Volume 8: Introductory Appendices

# Appendix A6.1

## Offshore Environmental Management plan (EMP)

North Irish Sea Array Windfarm Ltd (NISA, hereafter referred to as ‘the Developer’) has been considering the Request for Further Information (RFI) issued by An Bord Pleanála (now An Coimisiún Pleanála) as well as the third-party submissions received following public consultation. At An Coimisiún Pleanála’s behest, the Developer has also continued to consult with stakeholders in respect of the 2024 planning application throughout 2024-2026. The Developer has refined elements of the design to respond to the third-party submissions, the continued public and stakeholder consultation and the RFI. Amendments are therefore required to Appendix 6.1: Offshore Environmental Management Plan (EMP) of the 2024 Environmental Impact Assessment Report (EIAR). Full details of consultation undertaken can be found in Appendix A1.2 Consultation Report.

Figure A1 – Indicative Proposed Infrastructure of the proposed development (not to scale) (replacing Figure 2 of Appendix 6.1 of the 2024 EIAR)

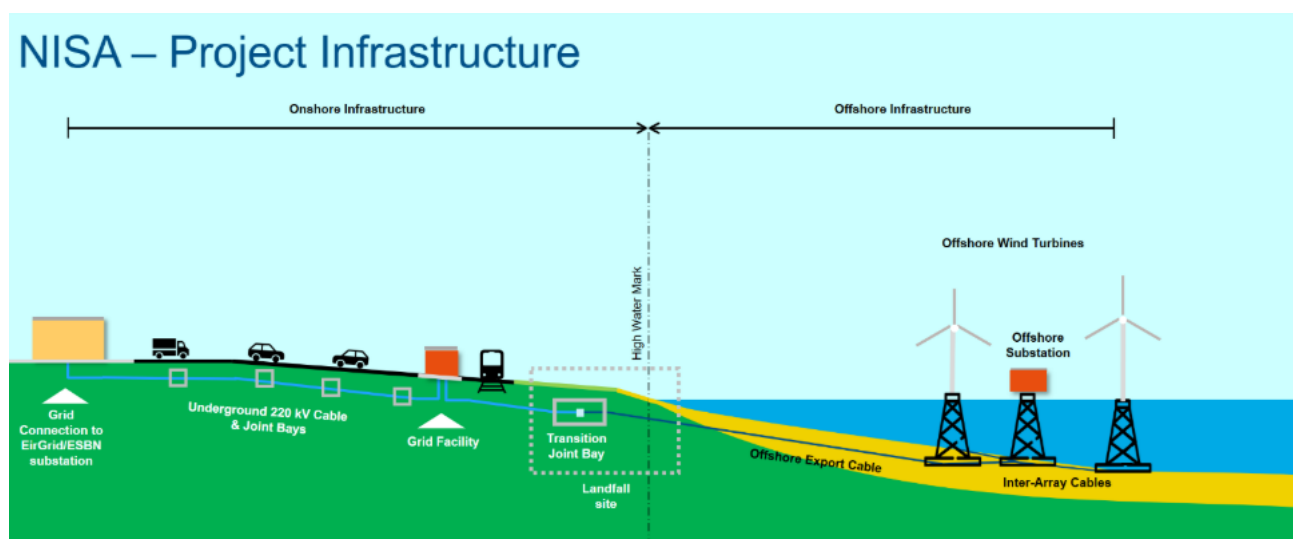
Following design refinements made in response to the RFI, wind turbine generators (WTGs) are now proposed with jacket foundations installed with suction buckets, and offshore station platforms (OSPs) with jacket foundations installed with either drilled pin piles or suction buckets (refer to Appendix A5.1: Design Refinements). Therefore Figure 2 of Appendix 6.1 of the 2024 EIAR shall be replaced with Figure A1 and Table 1 of Appendix 6.1 of the 2024 EIAR shall be updated with Table A1 below.
